SPECIAL MAINTENANCE INSTRUCTION No. RDSO/2011/EL/SMI/0266, Rev. '0', Dated 31.03.2011

Provision of compensating spacer ring between wheel disc hub and abutment piece (RWE) to eliminate possibility of shifting of MSU assembly of TM type 4303BY/C1005 (Fuji Design) of BHEL/CGL make used in AC-EMU.

RDSO ELECT DTE SKEL-4856
ALT '0'

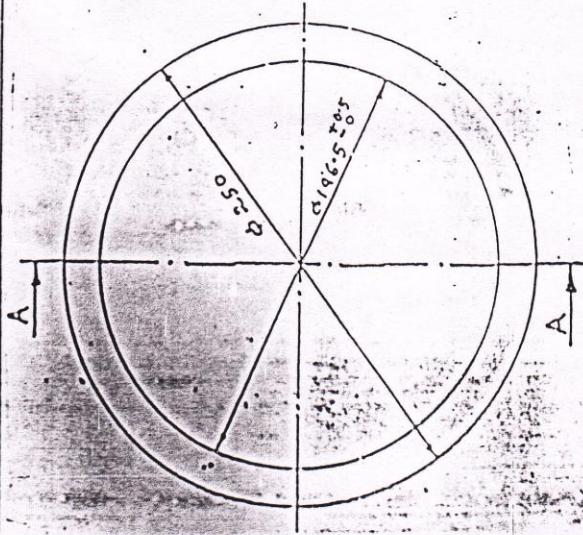
After detailed study, it has been decided to provide spacer ring of appropriate suitable thickness (1mm to 5mm) equal to the actual gap. This compensating spacer ring will bridge the gap between wheel disc hub and abutment piece (RWE) and so that wheel disc hub shall make positive contact with the abutment piece. This will eliminate the possibility of shifting of MSU assembly in TMs type 4303BY/C1005 used in AC-EMU.

- 5.3 Before pressing in the disc on RWE, the distance between abutment piece face towards wheel seating and shoulder of wheel seating on the axle shall be measured. Ideally, there shall be no gap in between the abutment piece face towards wheel seating and shoulder of wheel seating on the axle. If there is a gap, compensating spacer ring having suitable thickness equal to the gap shall be provided next to abutment piece and wheel seating to bridge this gap as per RDSO's drawing no. SKEL-4856, Alt '0

ITEM	THICKNESS
5	5 mm
4	4 mm
3	3 mm
2	2 mm
1	1 mm

NOTE: ALL SHARP CORNERS TO BE REMOVED
